**SAN ANTONIO WATER SYSTEM
DOS RIOS WATER RECYCLING CENTER (DRWRC)
DIGESTER MIXING AND SYSTEM ENHANCEMENTS PHASE I
PROJECT**

**SAWS Job No. 07-6500
Solicitation No. B-10-031-MF**

ADDENDUM NO. 5

August 3, 2010

ADDENDUM ITEM NO. D8

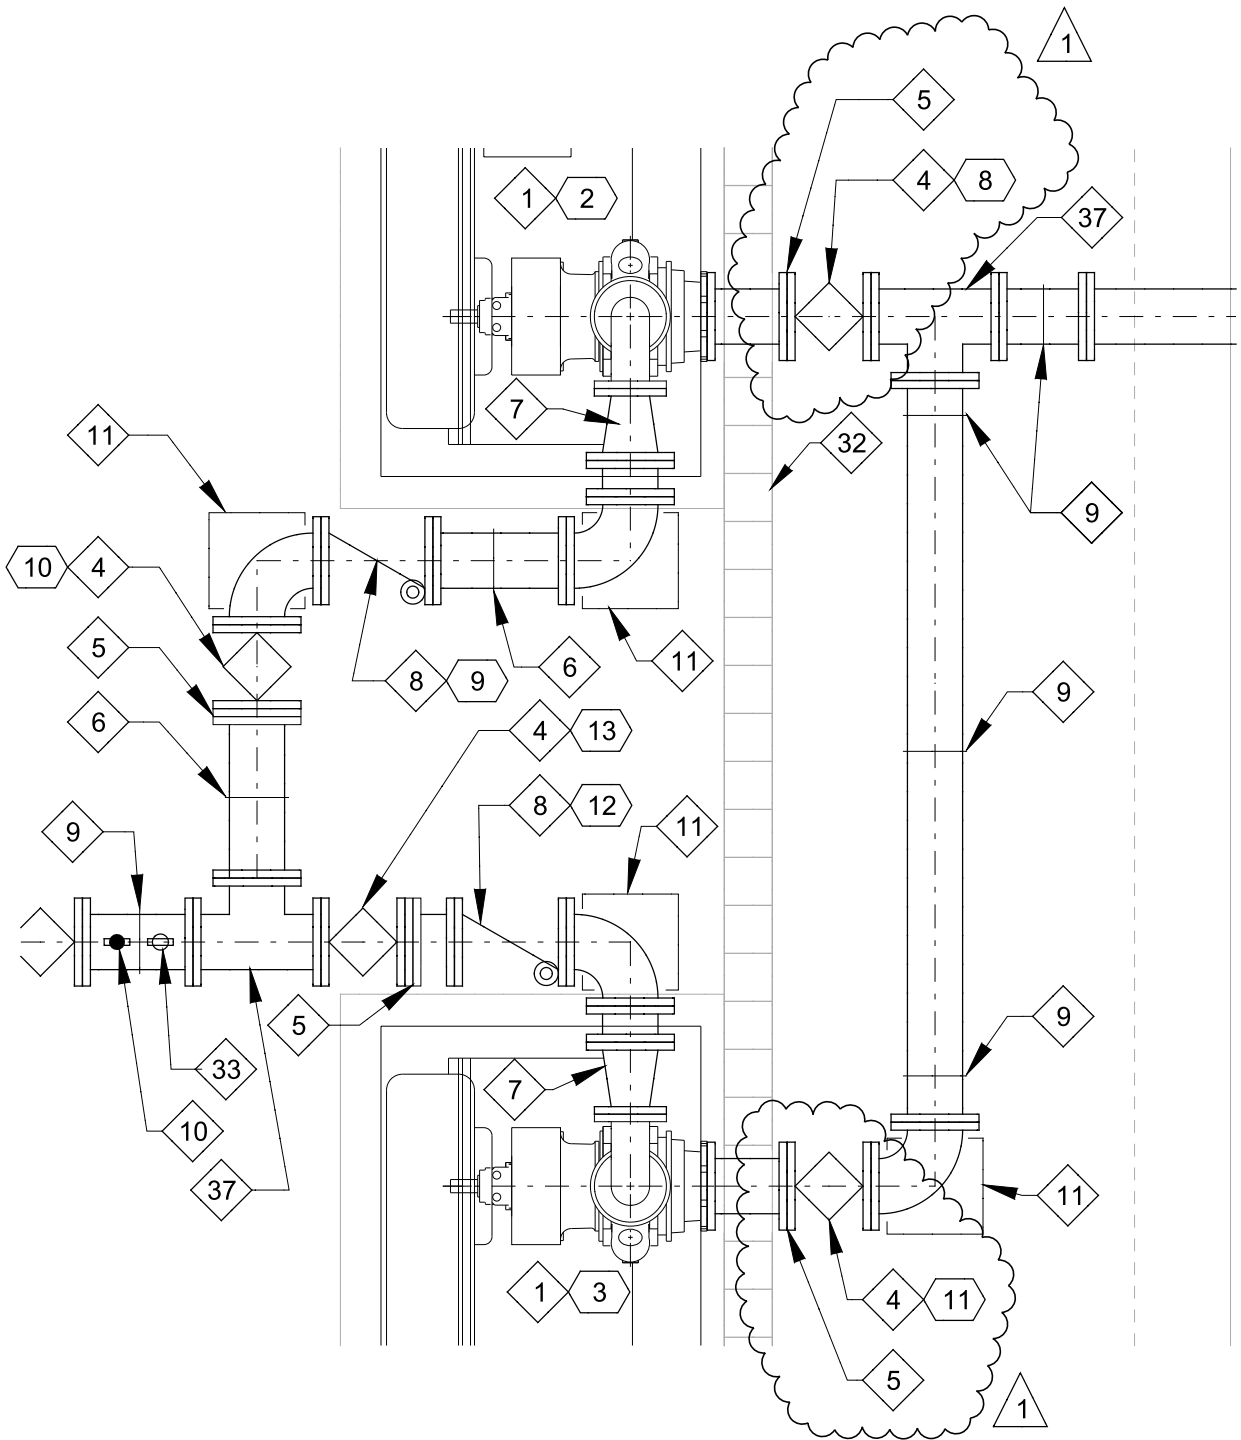
1. Drawing YP-C-01, REPLACE with attached drawing.
2. Drawing DM-M-03, MODIFY Detail 1 per attached Addendum Item No. D3.
3. Drawing DR-M-02, MODIFY Plan per attached Addendum Item No. D6.
4. Drawing DR-M-03, MODIFY Section E per attached Addendum Item No. D8.

ANSWER 25:	Provide butterfly valves.
QUESTION 26:	Section E on sheet 20 shows two motor-operated plug valves on the 10" csf line. However, sheet 107 has one valve as being motor-operated and the other is with a manual operator. Please clarify.

ANSWER 26:	See attached sheet D8.

ADDENDUM ITEM NO. D6

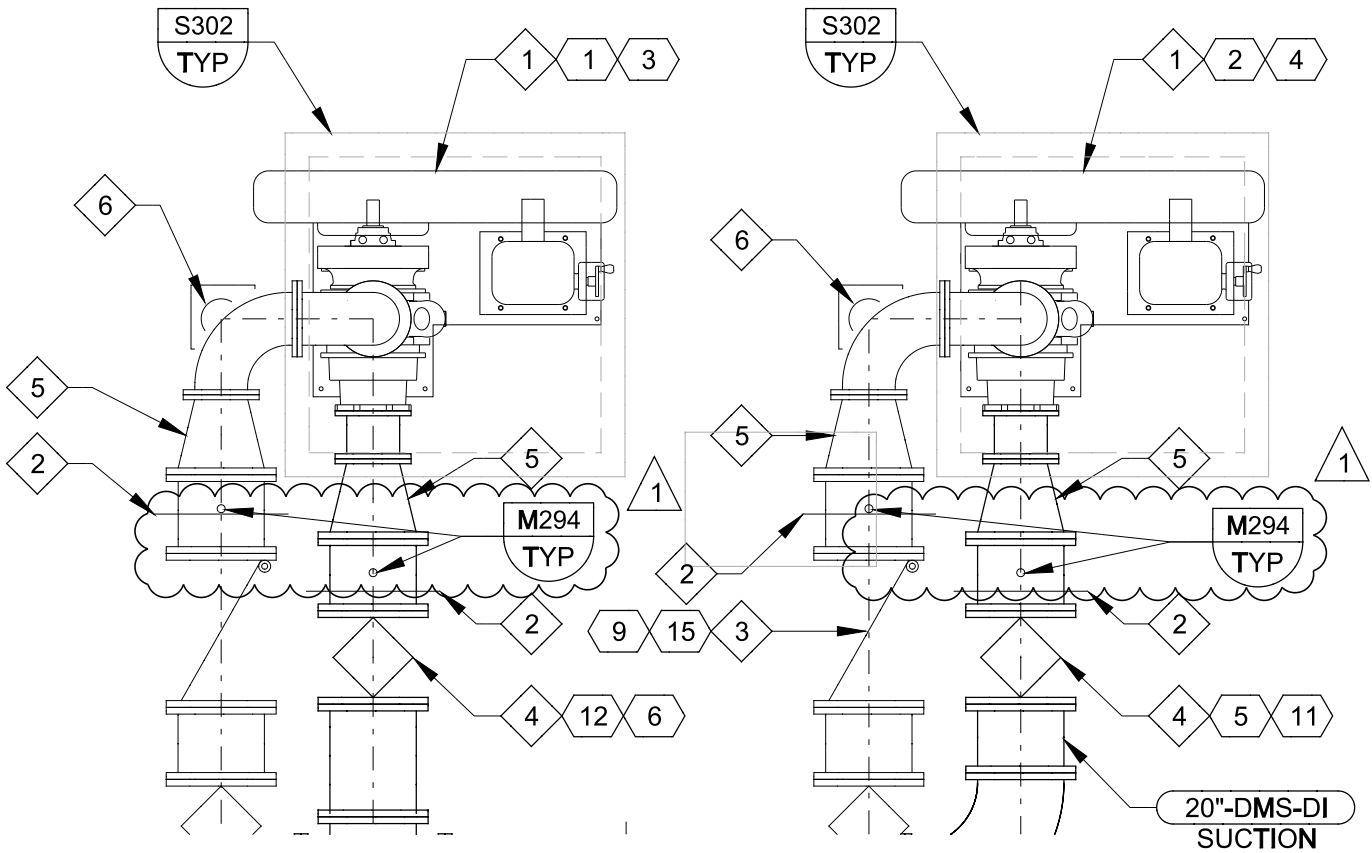
ANSWER 23:	See attached sheet YP-C-01.
QUESTION 24:	Sheet 108 shows two pressure seal devices on the recirc. Suction lines. However, sheet 19 doesn't show pressure seal devices on the recirc. Suction lines. Please clarify.

ANSWER 24:	See attached sheet D6.
QUESTION 25:	Sheet 19 shows butterfly valves on the hws and hwr lines. However, sheet 109 shows ball valves on the hws and hwr lines. Please clarify.

ADDENDUM ITEM NO. D3

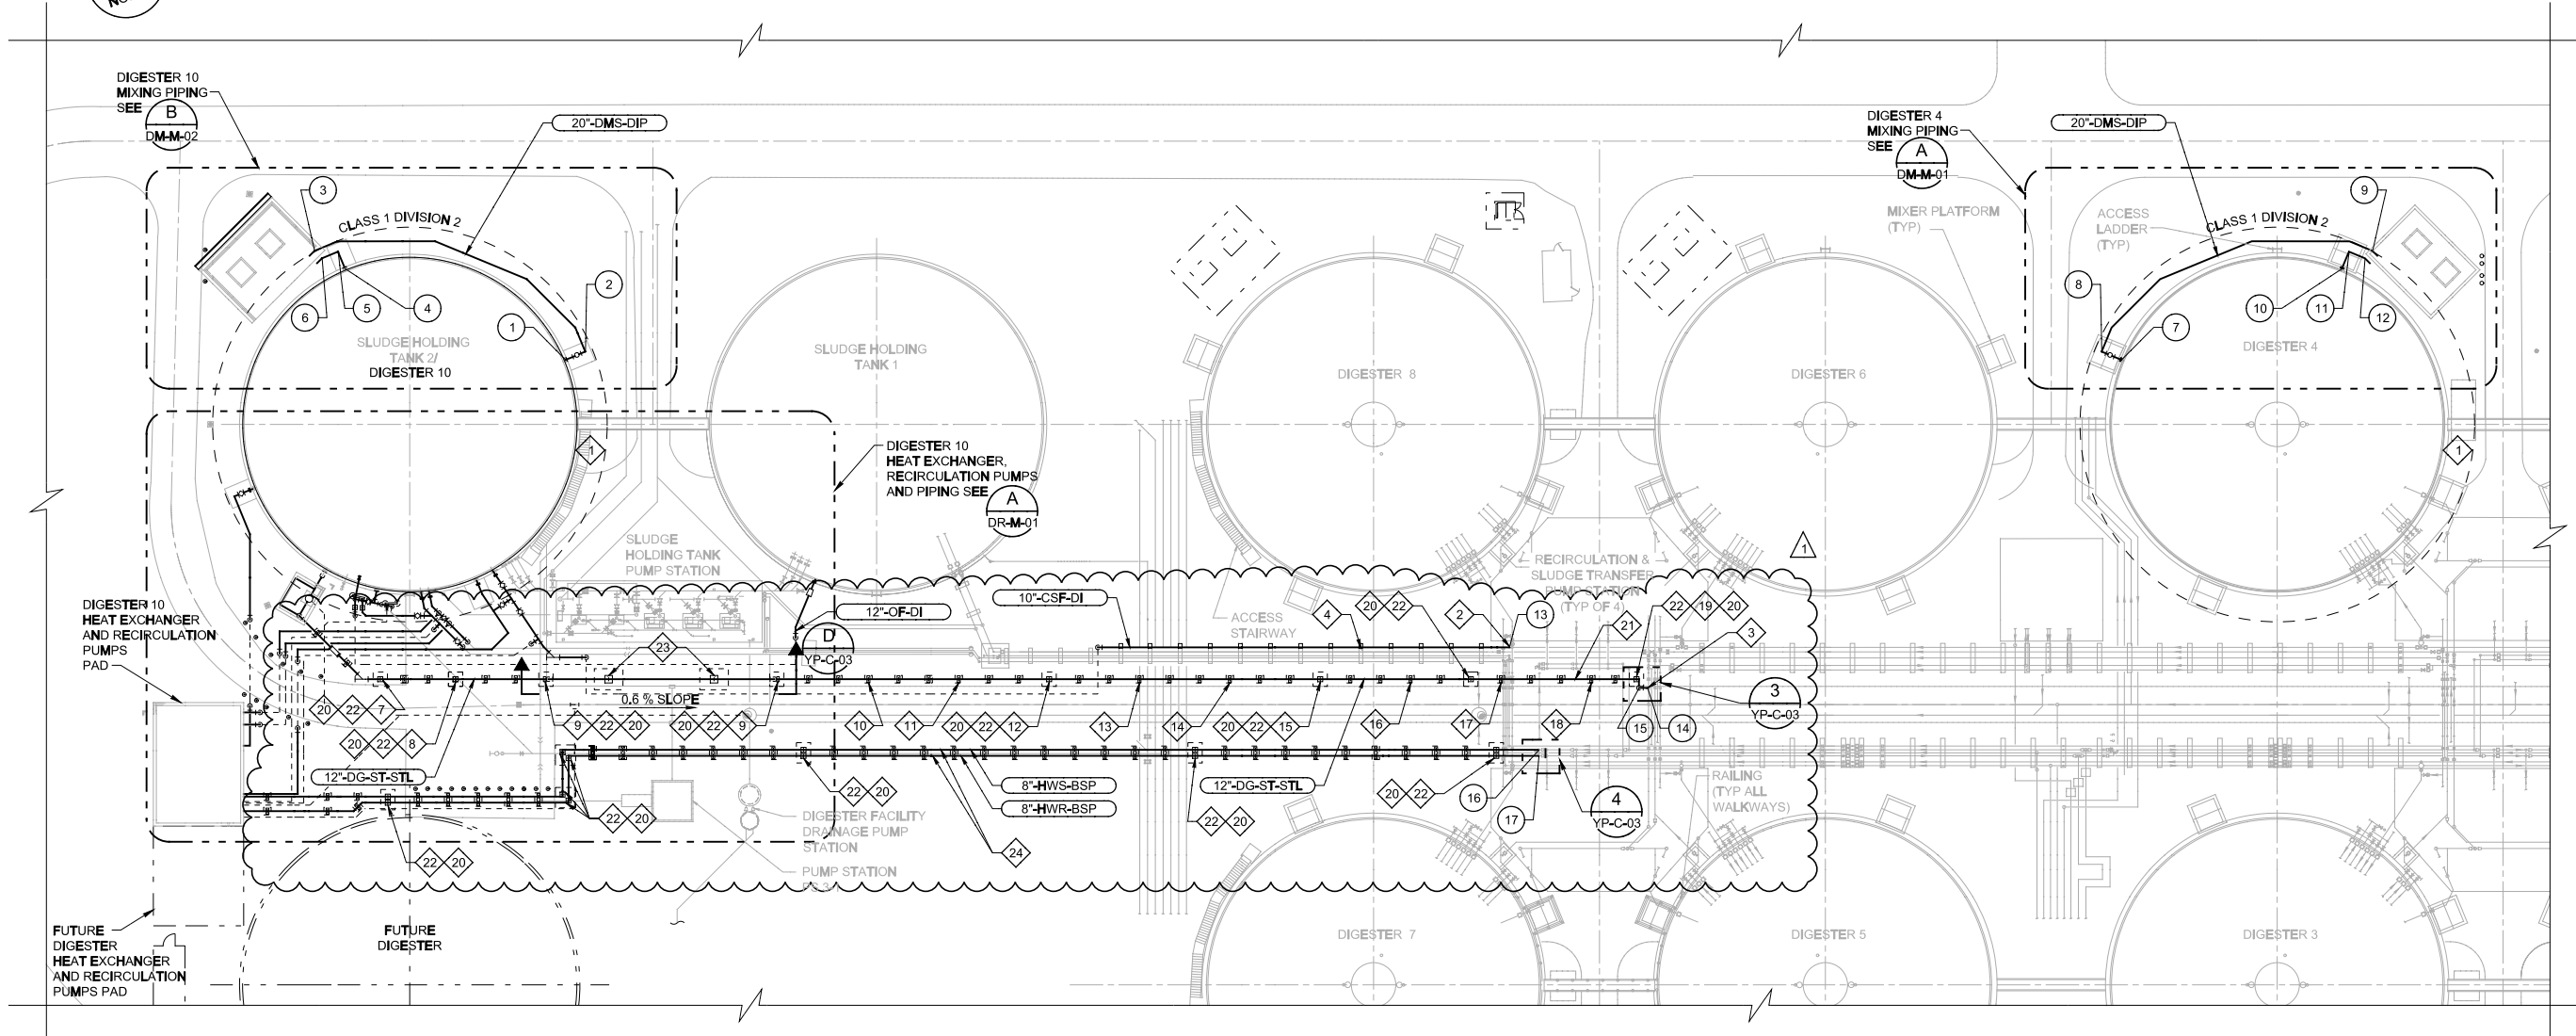
QUESTION 15:	Sheet 19 shows two pressure seal devices (key note 5) on the recirc. Discharge lines in between the pumps and the heat exchanger. However, sheets 108 and 109 only show one pressure seal device on the recirc. Discharge lines. Also, the one pressure seal device on the recirc. Discharge line that is shown on sheet 109 looks like it's supposed to be per detail np123 on sheet 44. However, sheet 19 calls it out as just a pressure gauge seal device (key note 5), that would make it be per detail np181 on sheet 44. Please clarify.

QUESTION 21:	Sheets 110 and 146 show four pressure seal devices at the mixing pumps (8 total; 4 per digester - 2 on the suction lines & 2 on the discharge lines.) However, sheets 34 and 35 don't show these pressure seal devices. Please clarify.

ANSWER 15:	See attached sheet D3.
QUESTION 16:	Please clarify the size of the hot water auto. Vent valves on the hws and hwr lines. This is key note 17 on sheet 19 and on sheet 20, Section J.

ANSWER 21:	See attached sheet D3.
QUESTION 22:	Sheet 109 shows there are four plug valves around the sediment trap on the digester gas line. However, sheet 27 only shows three plug valves around the sediment trap. Please clarify.
